Docket 8302

**STATE OF VERMONT PUBLIC
SERVICE BOARD**

PARTIAL MEMORANDUM OF UNDERSTANDING

Re: Chelsea Solar LLC 248 Petition (Docket No. 8302) – Petitioner’s Responses to the Vermont Department of Public Service’s First Discovery Requests

3D PERSPECTIVE - View B | Figure 2

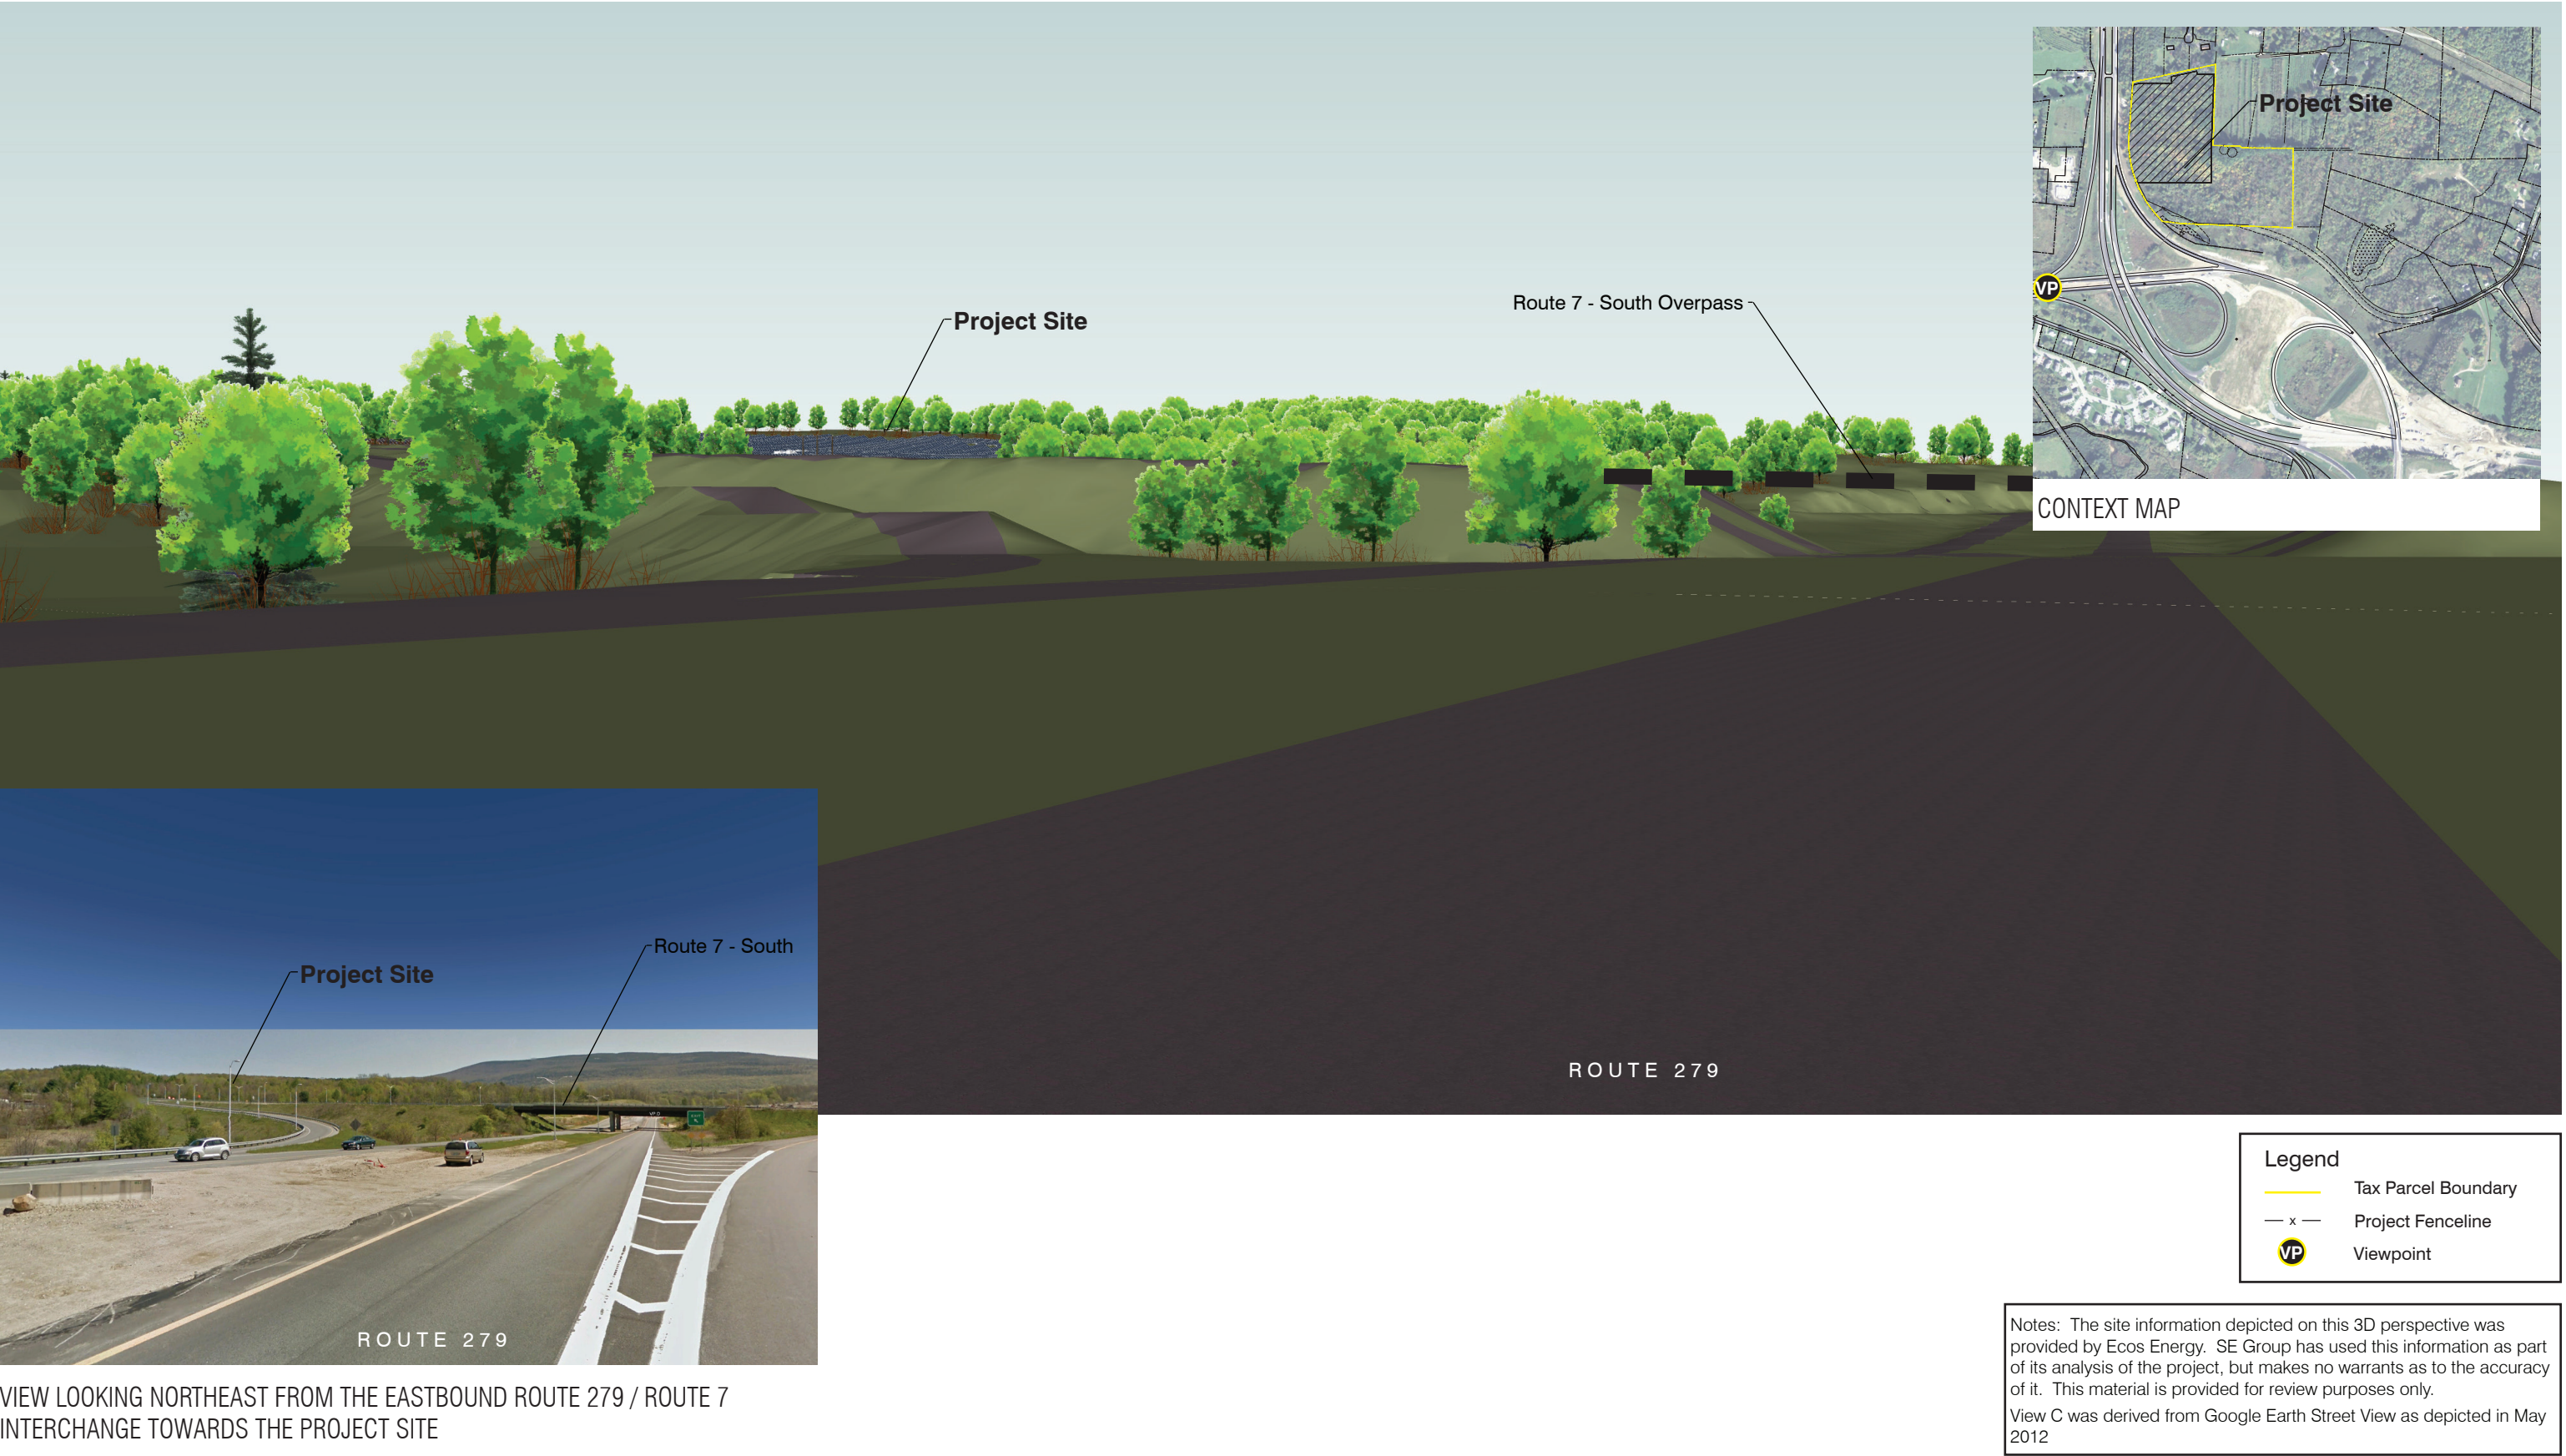
QUESTION 8: “Please provide a photographic simulation of the project from the vantage point of Route 7.”

RESPONSE 8: In this context, given the complexities of the road and transportation environment, getting photographs on the various approach ramps is unsafe. In lieu of a traditional photosimulation, I have prepared a 3D model view from various vantage points, including Route 7. A series of viewpoint indicators (black circles) are presented on the attached Figure 1 (Context Plan, November 20, 2014). These correspond to the same viewpoints previously referenced in my testimony and Visual Assessment Report (Exhibit Petitioner MK-2, June 19, 2014). Viewpoint “B” as shown on this new Figure 1 and as described in my early report, is within the southbound lane of Route 7, to the west of the Project site. Figure 2 of this discovery response (3D Perspective – View B, Dated November 20, 2014) provides a 3D model simulation of the view from this viewpoint “B”. The reference photograph (existing conditions) is shown in the lower left corner. This simulation illustrates that from this location, intermittent glimpses of the rear (back) of some panels might be possible through retained vegetation along the western edge of the Project. The density of the understory, as shown in the reference photograph, coupled with the likely darkening of the shadowed “back” sides of the panels will greatly curtail the appearance of the Project. The 3D modelling does not address shadowing. It should also be stressed that this view would be to an observers left and not a primary focal point. It is located on a major roadway with a high travel speed (55 mph), so any glimpses would also be short in duration.

3D PERSPECTIVE - View C | Figure 3

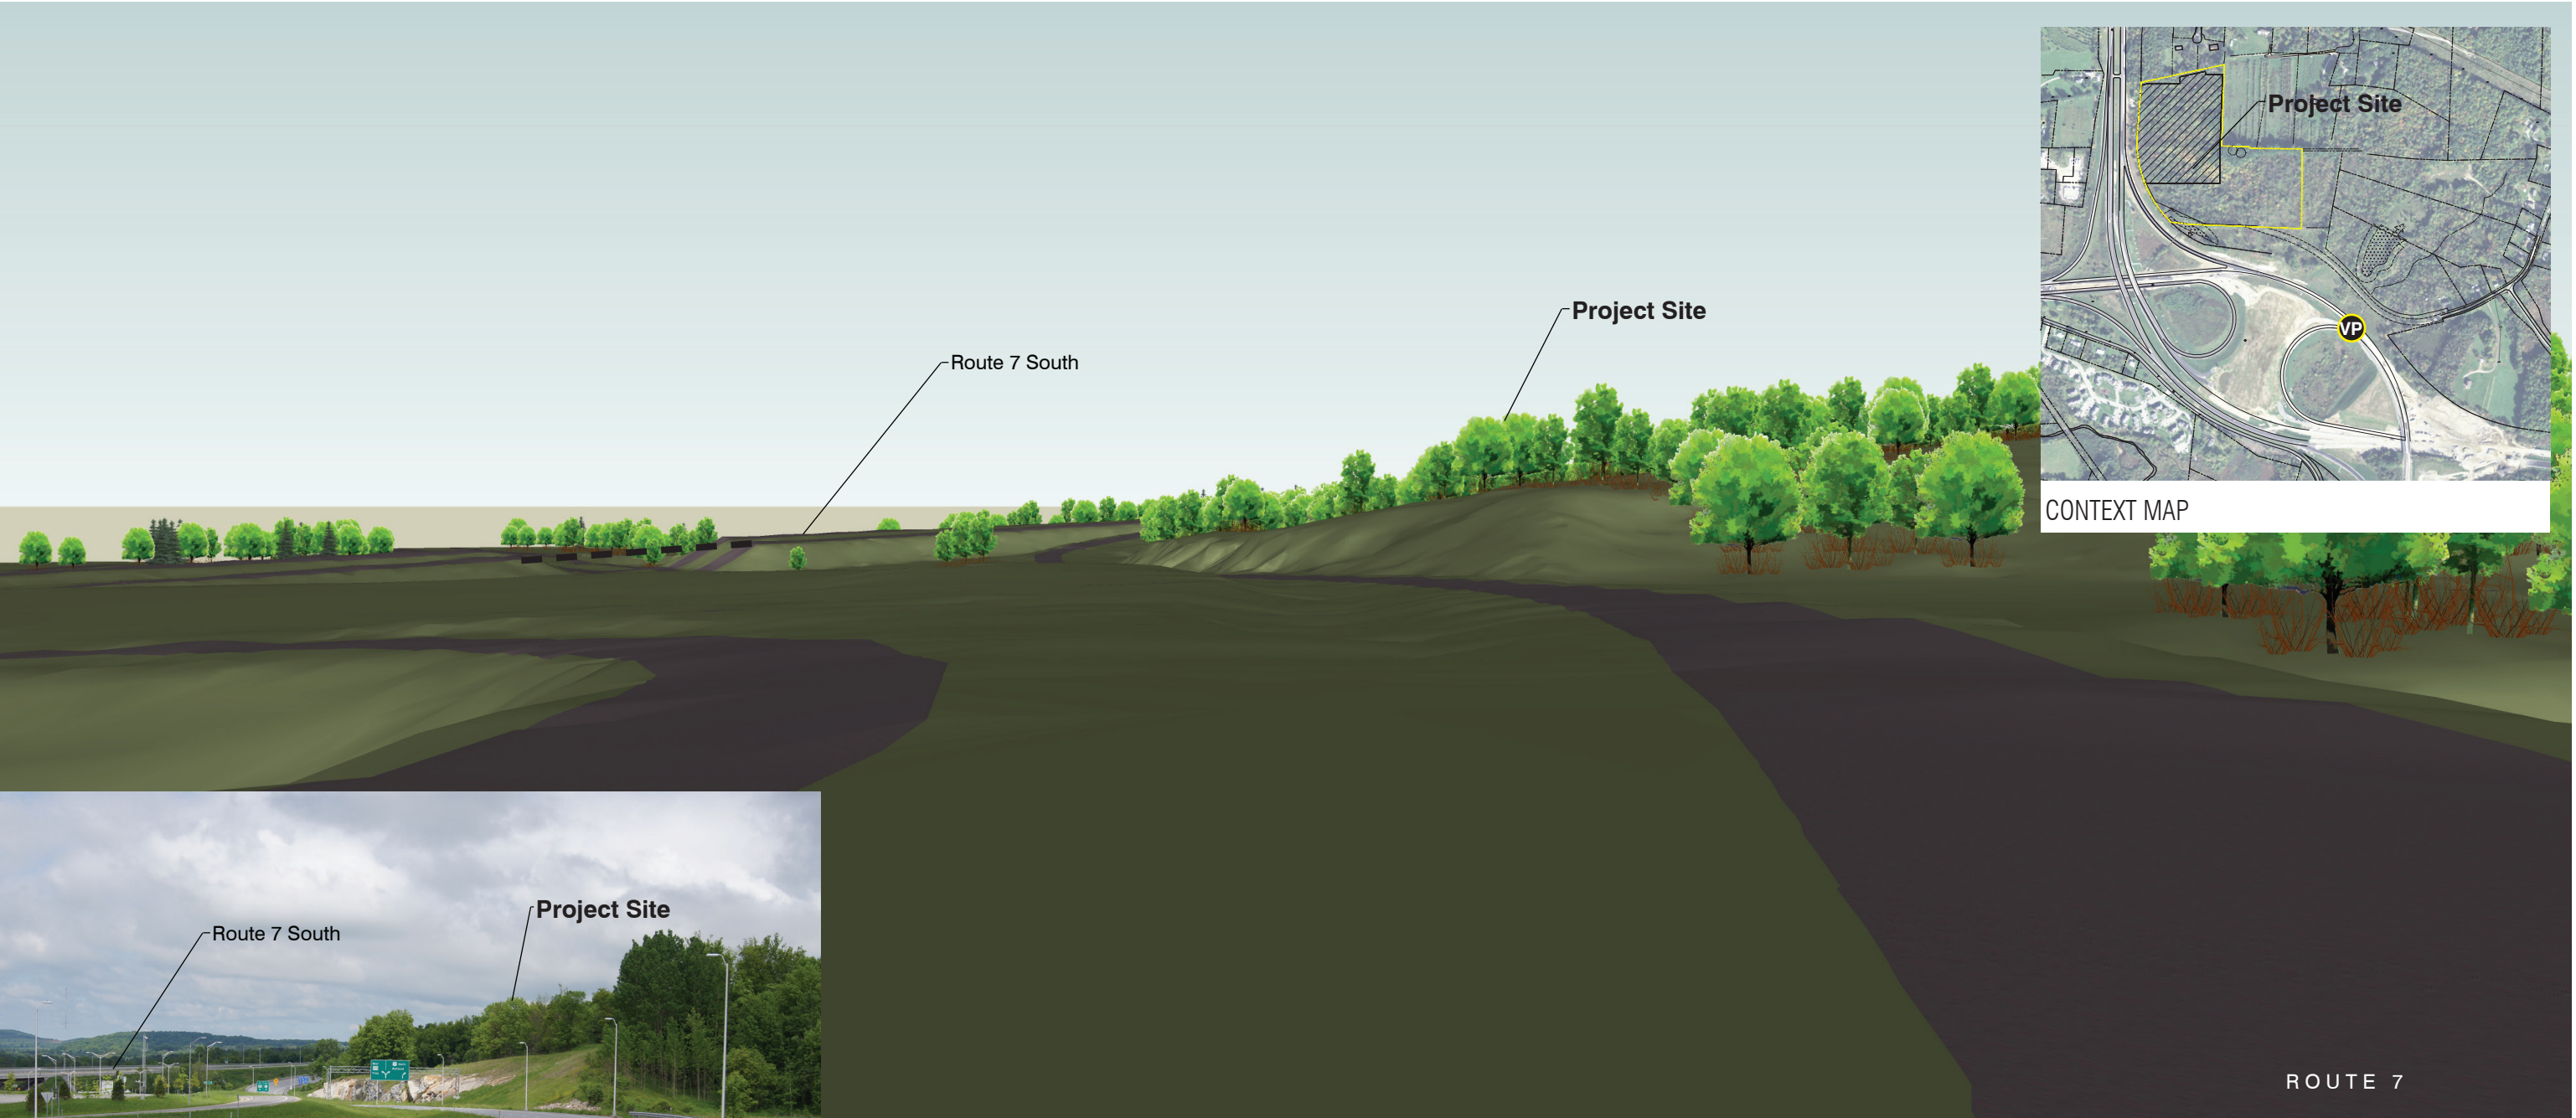
QUESTION 10: “Provide a photographic simulation of the project or illustrate the extent of the project and clearing on a photograph from Route 279 at approximately Viewpoint 1 (see Visual Assessment Report on page 16). Will the inverter structure be visible from this vantage point?”

RESPONSE 10: Similar to my response in Question 8 above, I have prepared a 3D simulation of a viewpoint identified as “C” which is on 279 heading eastwards about 0.4 miles away from the Project. This simulation is provided as Figure 3 (3D Perspective – View C, dated November 20, 2014). The simulation show visibility of a small portion of the array though a small gap in the existing woods along the Route 7 corridor (western edge of the Property). This is the area where I had previously recommended mitigation (See Figure 2 from my Visual Impact Assessment Report, dated June 19, 2014). While this new 3D simulation includes the mitigation, given the orientation of the observer from this location, those plantings will not (at time of installation) screen all elements of the Project. The inverter, or a portion thereof, may be visible from this location. The direction of view from this location is such that an observer would have to be looking to the left, not forward. Given that this location is a slip lane on 279 where observers will be traveling at a high rate of speed, the Project is not a focal point and any views would be of very short duration and not likely to make any significant impression.
